In the Drawings:

Please approve the proposed drawing revisions as shown in the concurrently filed Request for Approval of Drawing Revisions with annotated marked up drawings and replacement sheet.

FIG.2

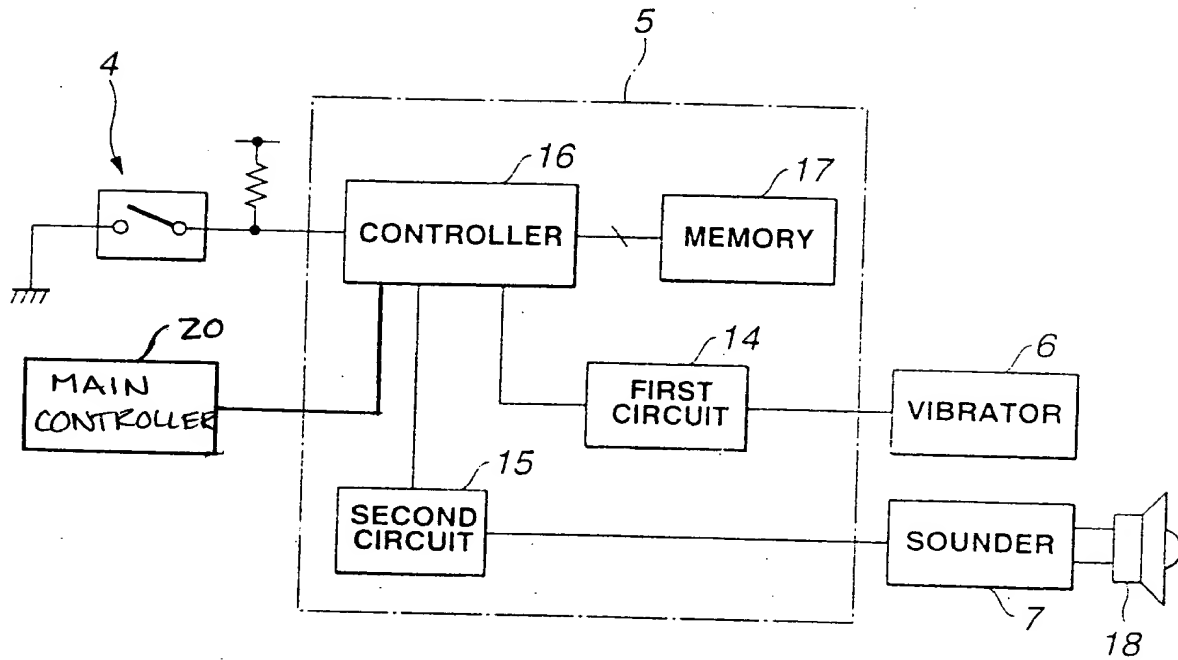
Figure 2 has been amended to include main controller 20 as discussed in the specification:
